From: Gray, Jane K - DNR <jane.gray@wisconsin.gov>
Sent: Wednesday, November 20, 2024 4:04 PM
To: Pratap Singh <psingh@ksinghengineering.com>
Cc: Angy Singh <angy.singh@ksinghengineering.com>; Robert Fedorchak <rfedorchak@patrioteng.com>; Kathryn Balachandran <kbalachandran@ksinghengineering.com>; Shane LaFave <Shane@roerscompanies.com>; Que El-Amin <que@scott-crawford.com>; Walden, James E -DNR <jamese.walden@wisconsin.gov>; Mylotta, Pamela A - DNR <Pamela.Mylotta@wisconsin.gov>
Subject: CWC East Block (02-41-263675) - Request for Information

Community Within the Corridor - East Block

Ground Level Map showing VMS Layout and SSV Pins

VAPOR MITIGATION SYSTEM COMMISSIONING – NR 712.09 CERTIFICATIONS
THIRD ROUND OF COMMISSIONING

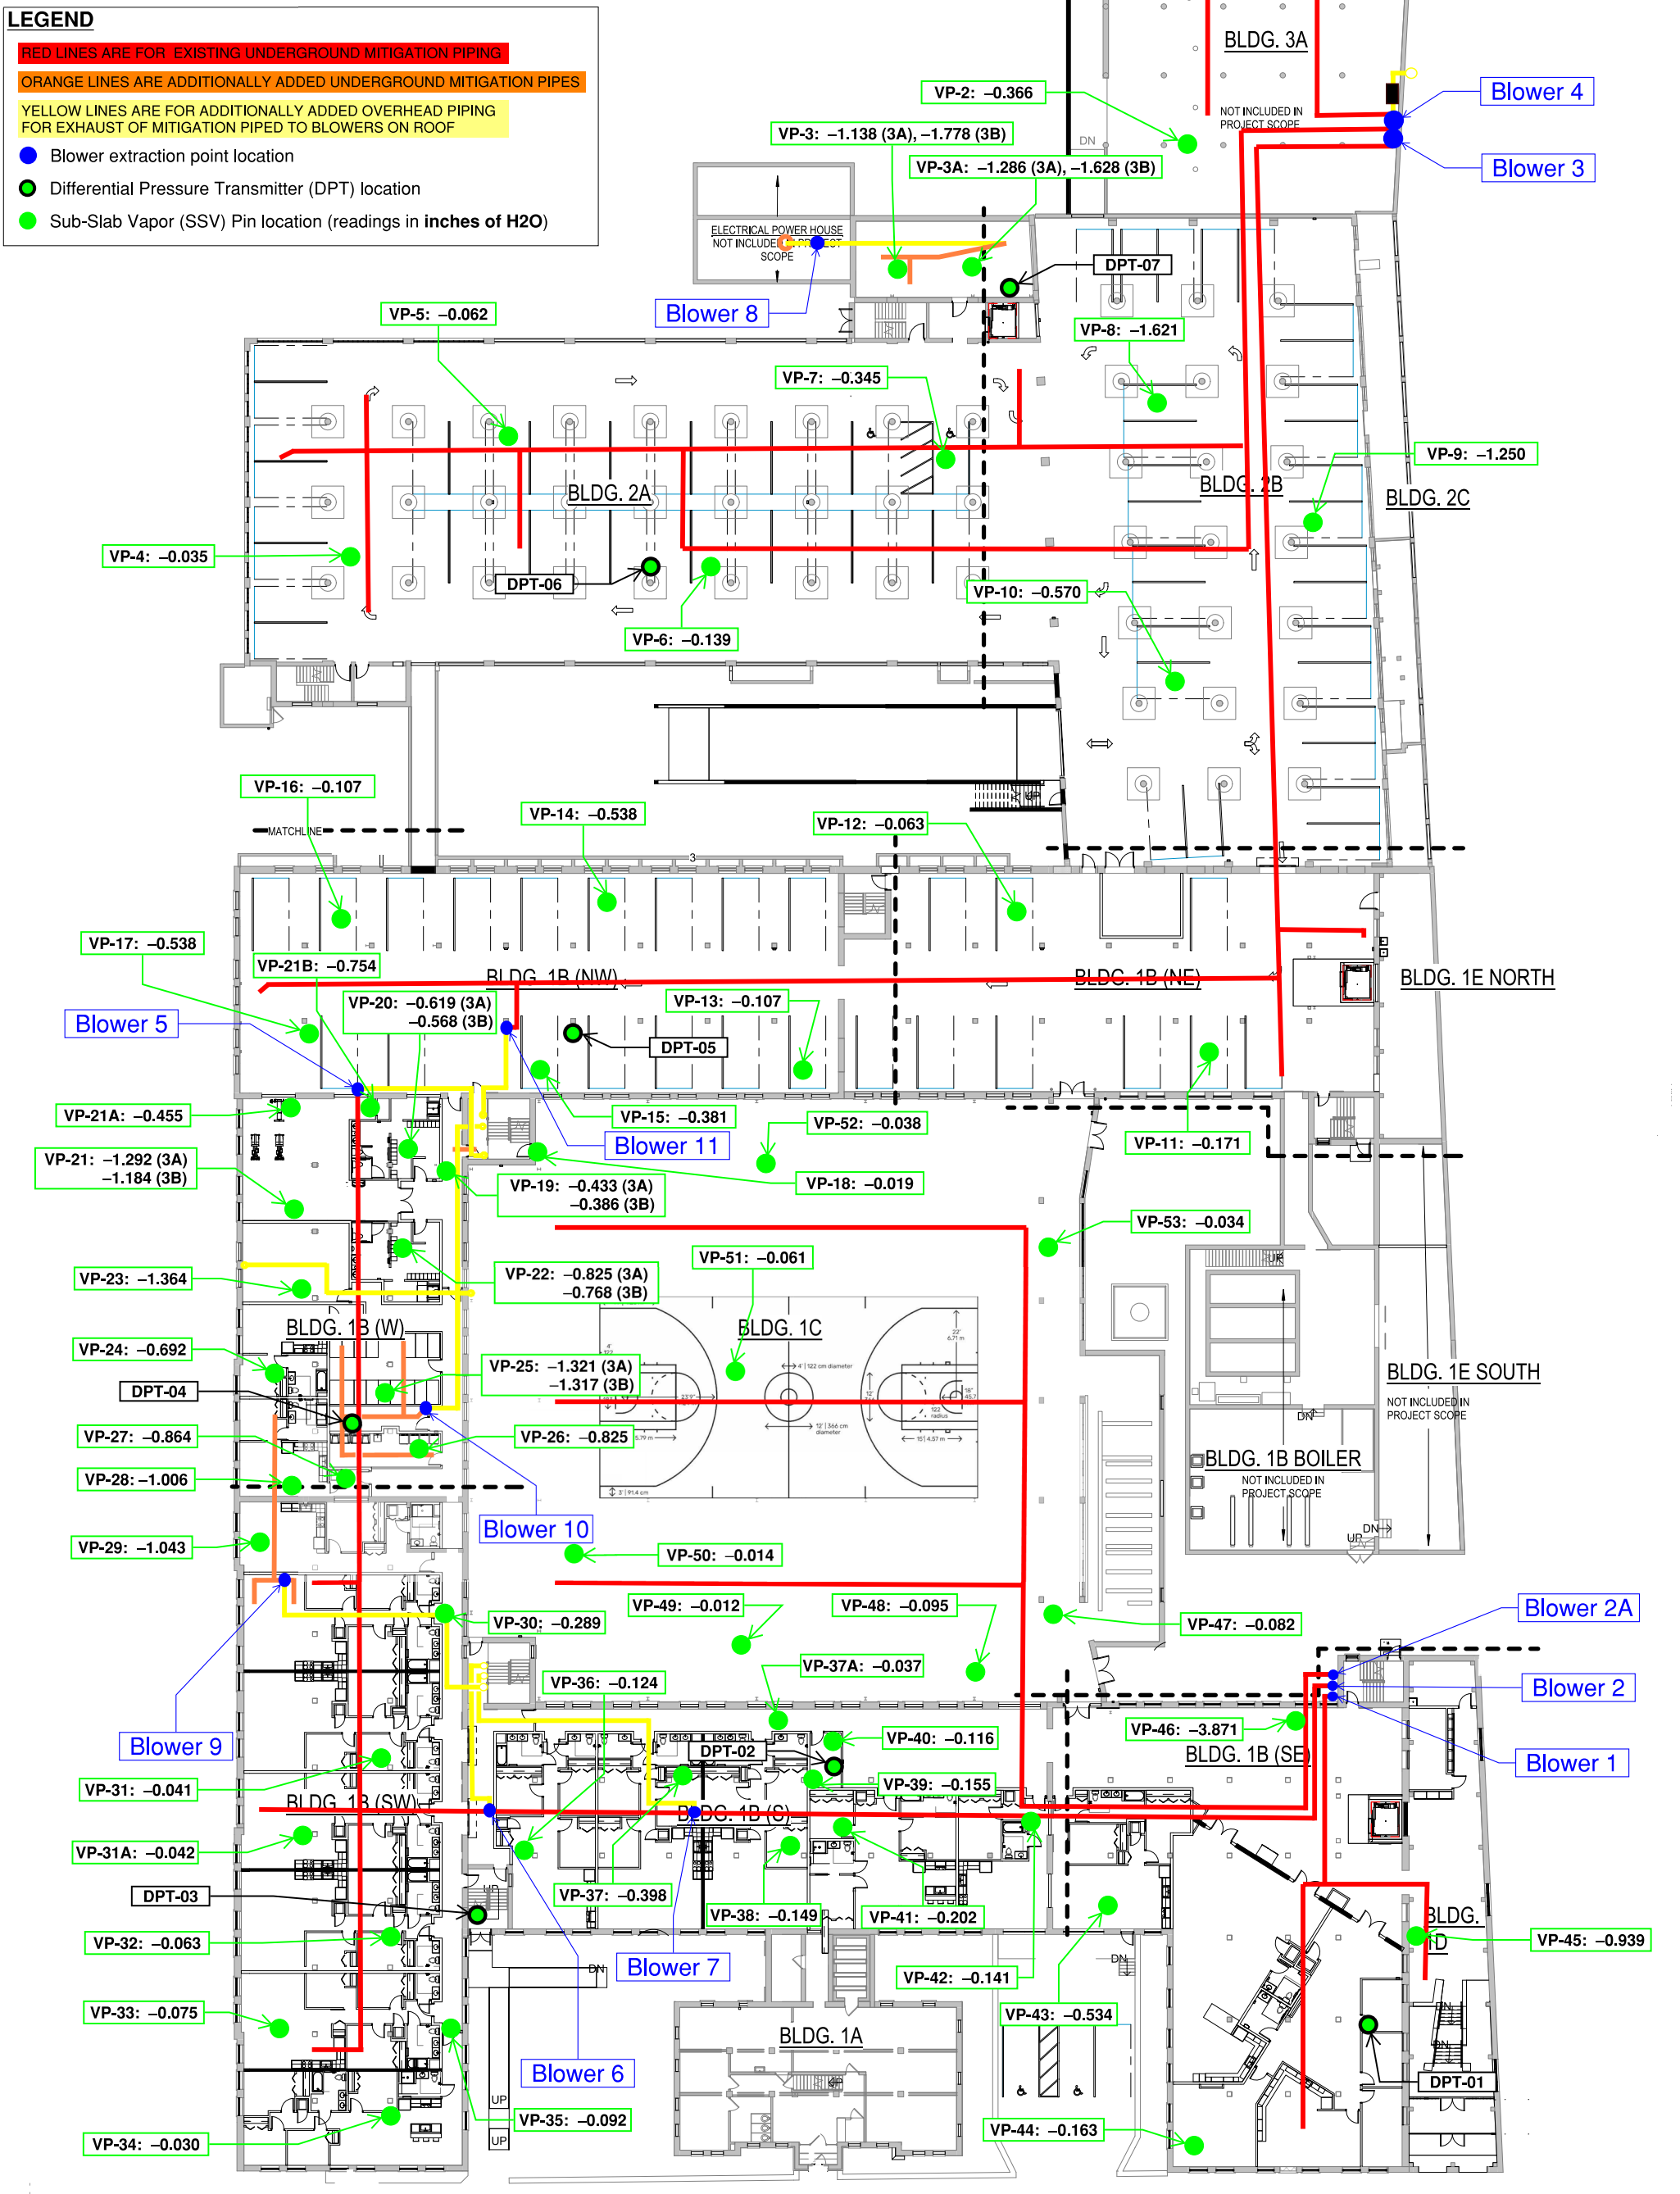
- In our opinion, the level of indoor air quality testing performed during Round 3 is unprecedented, and certainly indicative of the environmental restoration achieved by CWC.
- Provide a figure displaying both the PFE information and the VMS layout with relevant piping, valves, vacuum measurements and discharge points, as requested in the 05/30/24 letter.
 - The requested figure is included as an attachment to this memorandum.
